# Rhode Island Airport Corporation

## ADDENDUM NO. 4

Invitation for Bids No. 32231R

PVD Canopy Drainage Repairs and ADA Modifications

C0.04

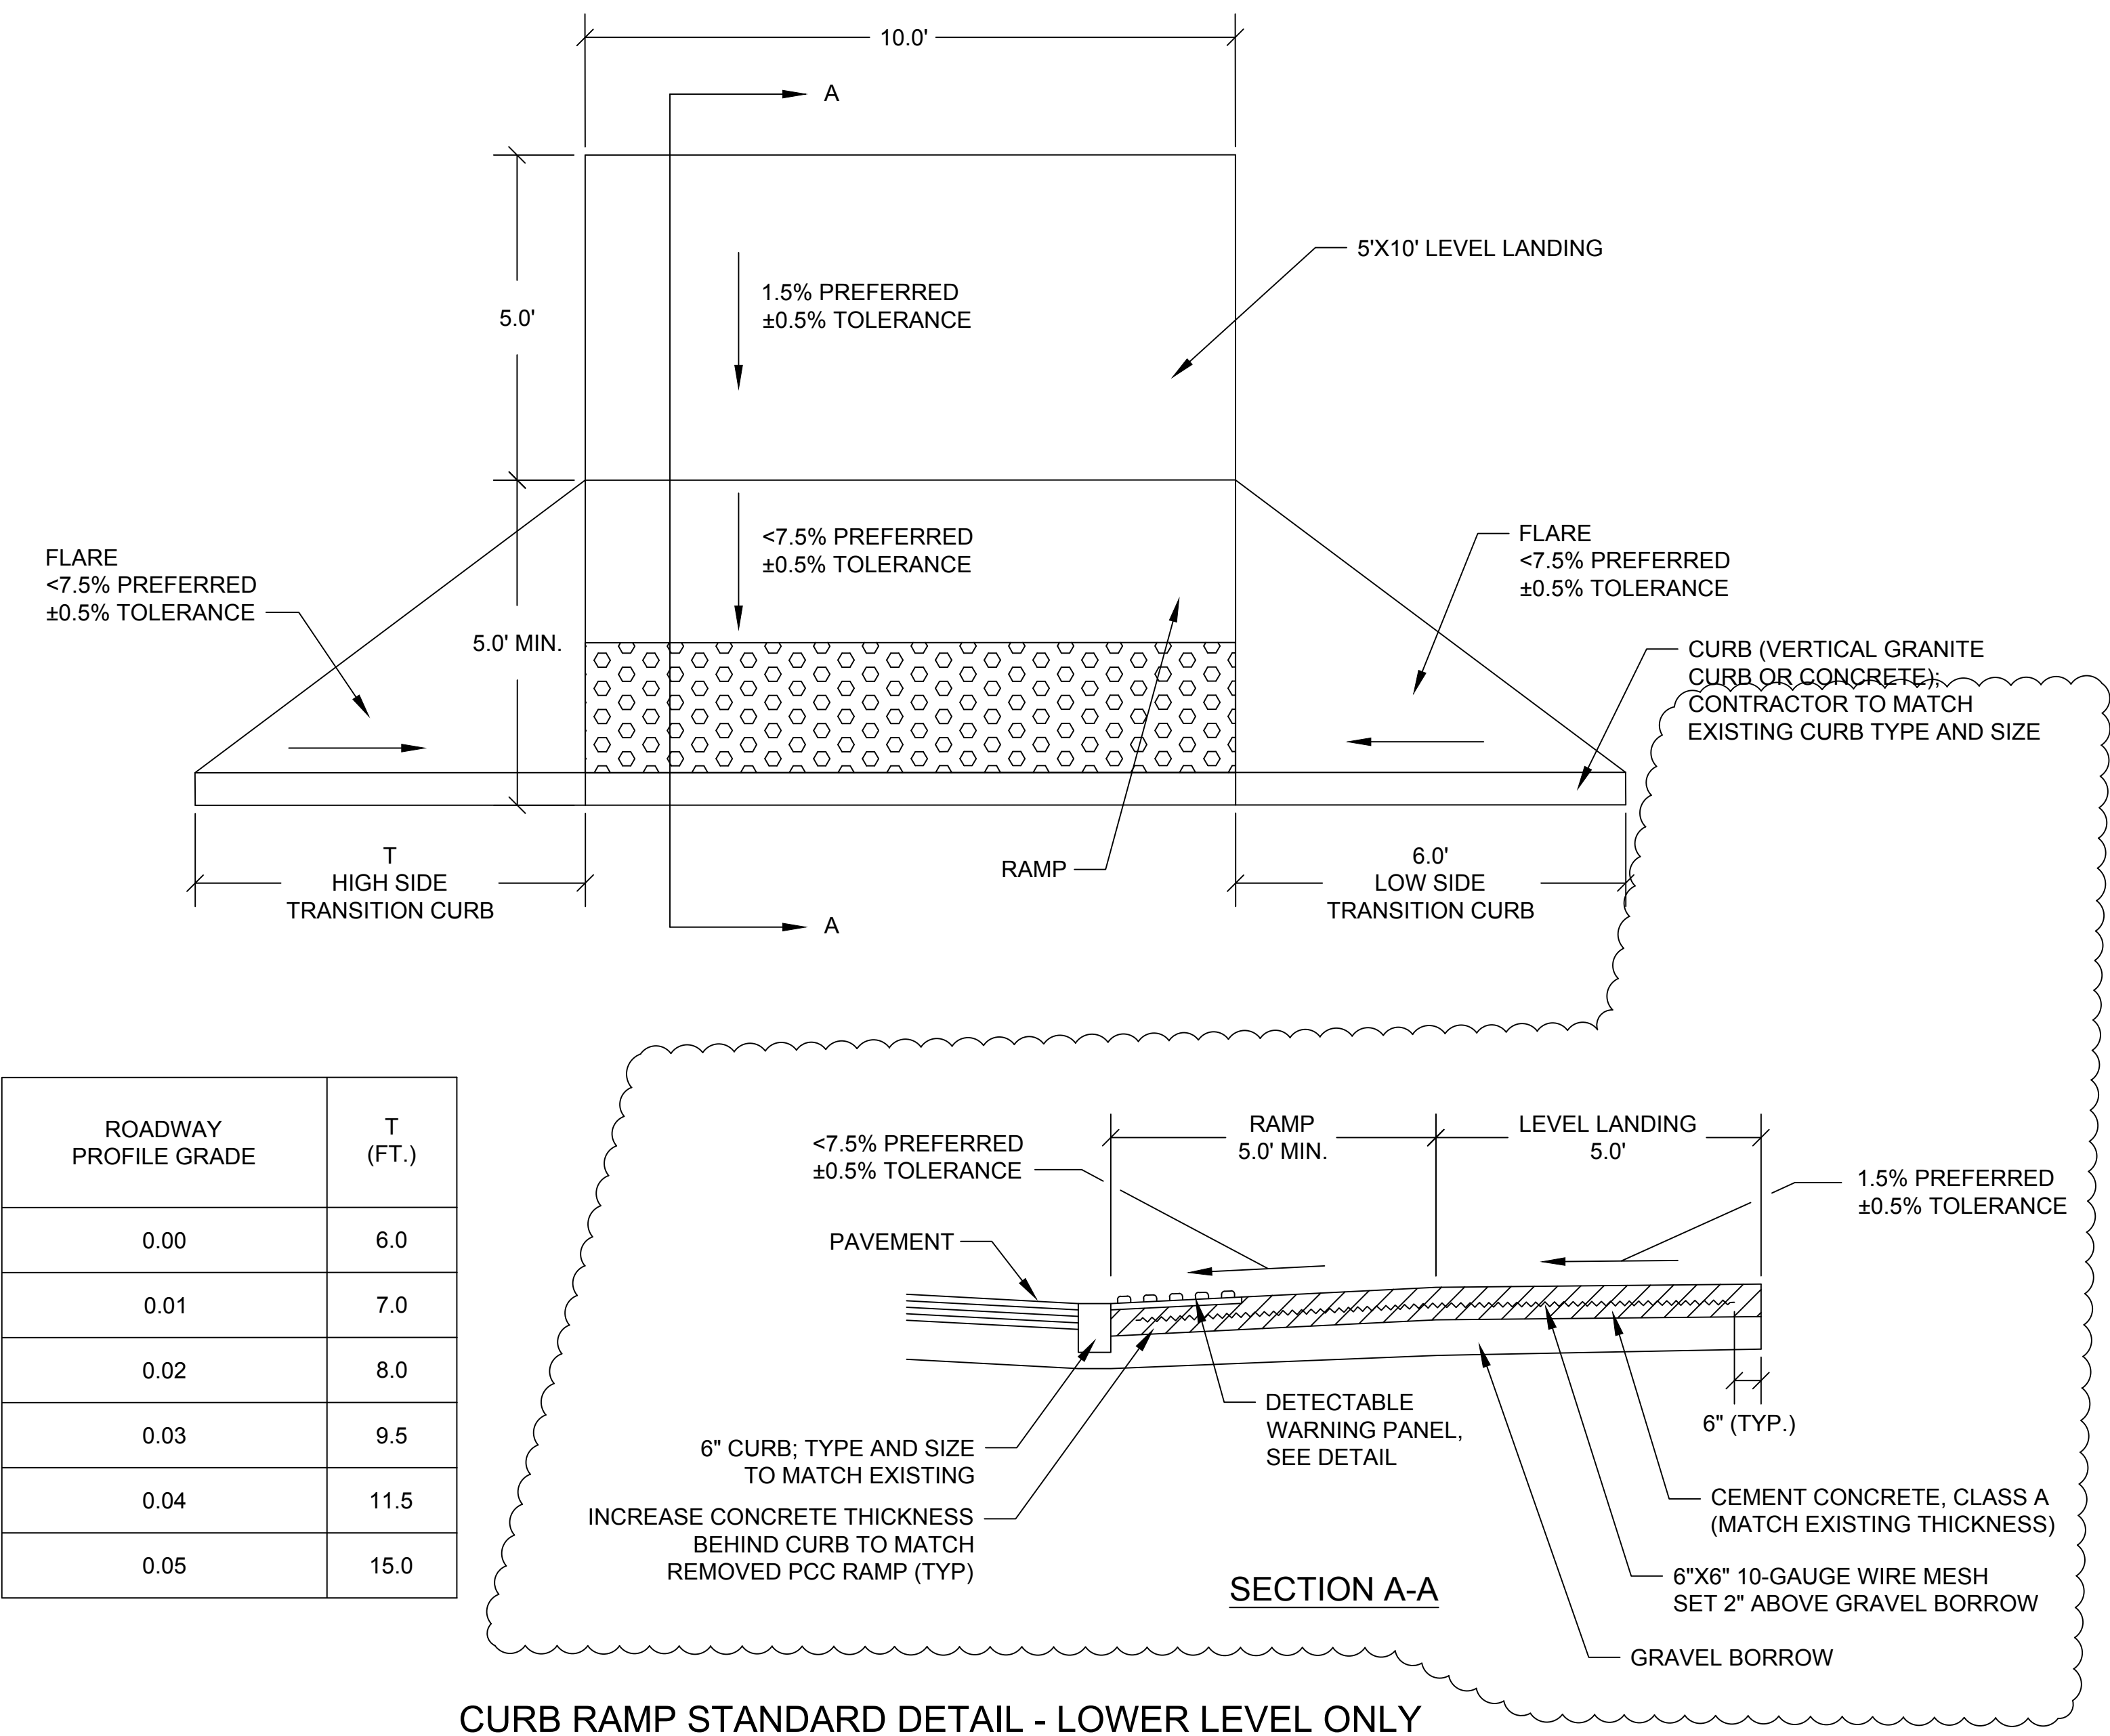
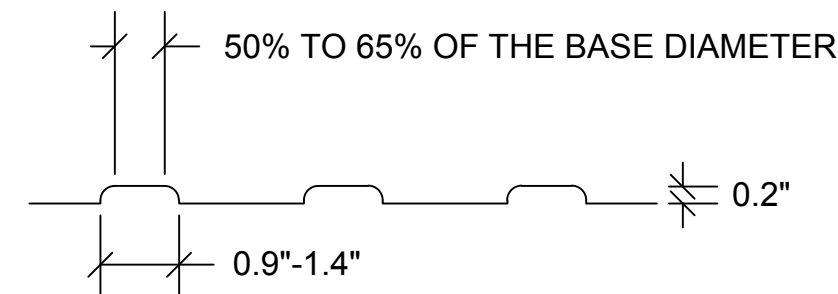
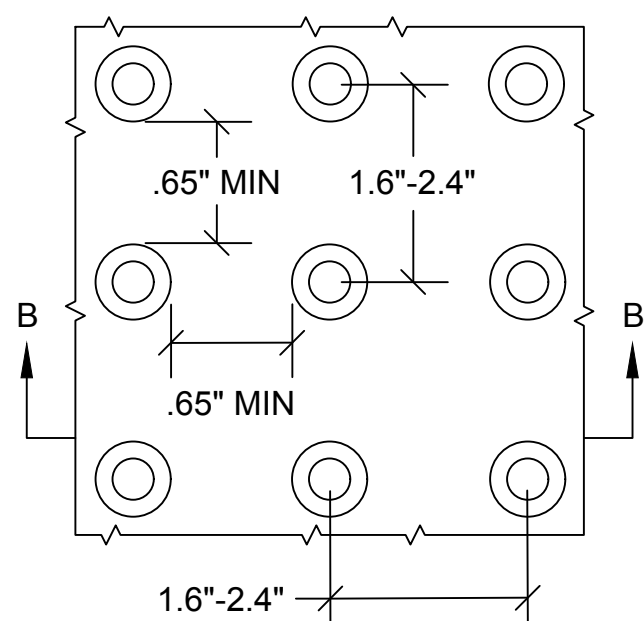
- d. Regarding the ramp detail on C0.04, what is the thickness of the ramp, is there a haunch at the curb line, what type of reinforcement is required, and how is the ramp doweled into the existing concrete?

**It is the intent to replace the existing concrete section in kind, matching the adjacent concrete thickness. The replacement in kind also applies to any existing haunch behind the curb. Reinforcing wire has been added; refer to the revised Drawing No. C0.04 (attached). No doweling is proposed as part of the project.**
